REFERENCE LHC-TC-EC-0015

ENGINEERING CHANGE REQUEST

**Upgrade Of The Crystal Collimation
Test Stand in IR7**

Figure 1 — 3D view of the horizontal goniometer setup: the crystal can be inserted into the beam only when the C-shape replacement chamber is moved out (on the bottom in the figure). The 3D reference corresponding to the crystal collimator in the horizontal configuration is the ST0563346_01.

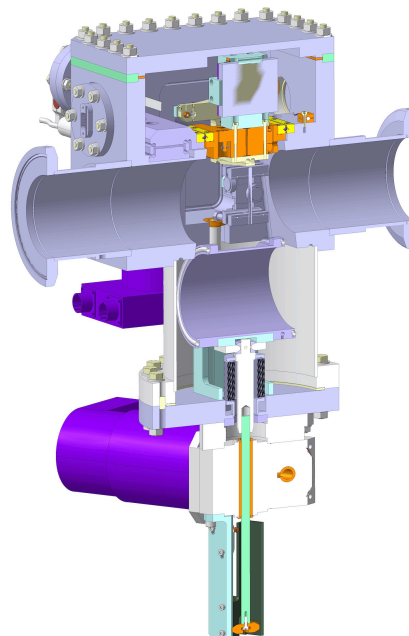
At this stage, we assume that the design of the TCPC assembly remains very similar to the presently installed hardware, see Figure 1. It relies on a movable replacement chamber that allows inserting the crystal close to the beam only in its “out” position. In standard operation for proton beams, this replacement chamber will be in its “in” position and hide the crystal from the circulating beam.

As a design requirement, possible design modifications from the present hardware must fit into the present installation slots, so that the present assemblies can be replaced with minor changes (as for example it was described in [4]). At this stage, we also assume that no additional controls cabling is required and that the present ones will be used in case new TCPCs are installed.

The detailed description of which one(s) of the 4 TCPCs shall be changed in LS2 will follow after the experiments’ results in the LHC, through an update of this document. At this stage, we assume conservatively – for resource estimates – that all the 4 TCPCs shall be replaced.
